ROM Board Logic Diagram

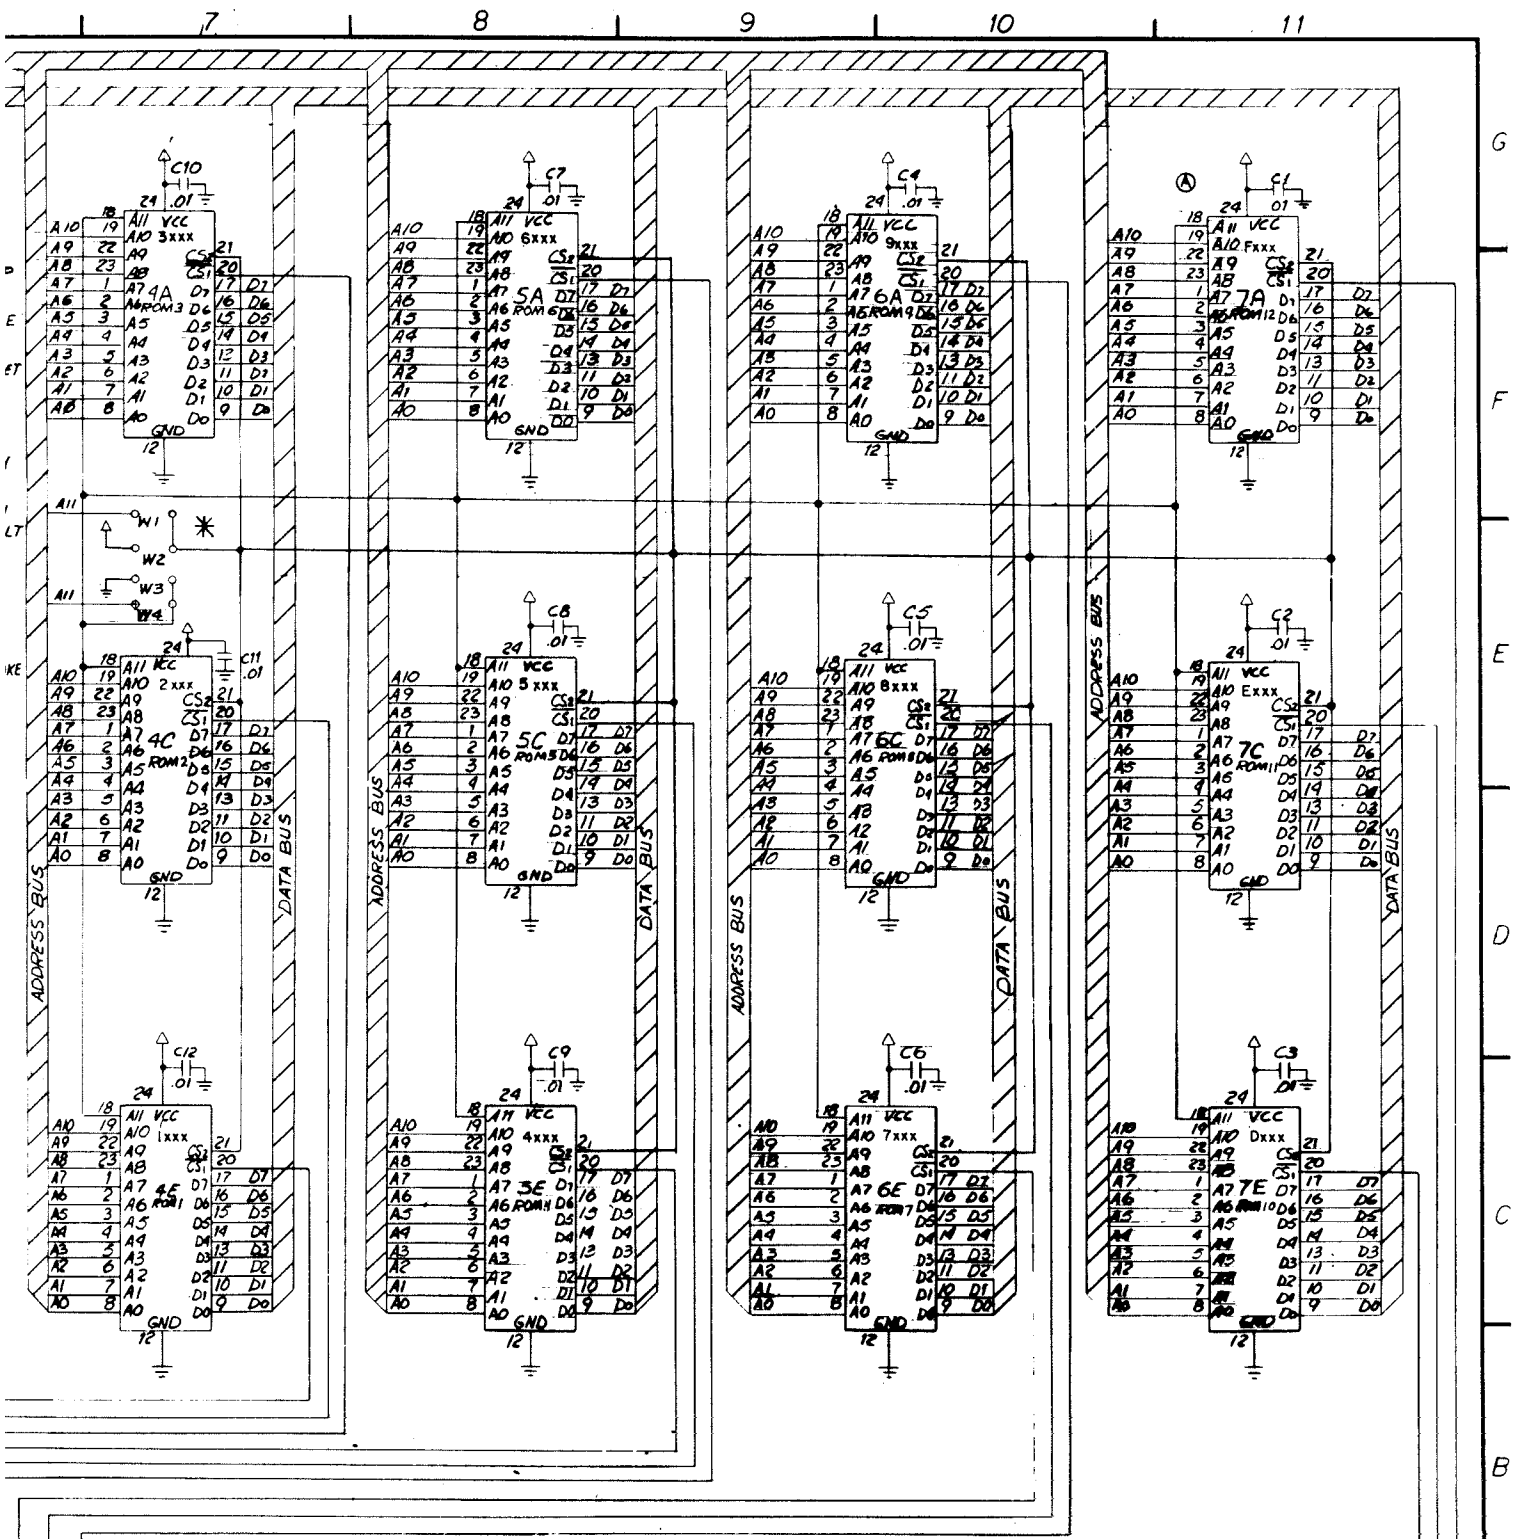
C	PIA, IC PINS 35E 36 WAS GOING TO DATA-BUS. IC, 2E PIN 14 WAS 11, REVISED KCC70C2, 8-20-81, 76.5, E.C.O. 7644	C.D. 7/1/81
B	UPDATED SCHEMATIC. WINNIE WAS WINNIE. I ADDED MISSING 'A2EAS' CALLOUTS. IC ROM WAS ROM B, SC ROM WAS ROM S, AND EXCHANGED 'E F' CALLOUTS 8-4-81, J.C.C.	C.F. 6/1/81 E.C.N. 7342 8-14-81
A	TA WAS ROM B; TE WAS ROM F. T-T-81, E.C., E.C.O. 7657	C.D. 7/1/81 P.H.N.
REVISION LETTER	REVISION	BY
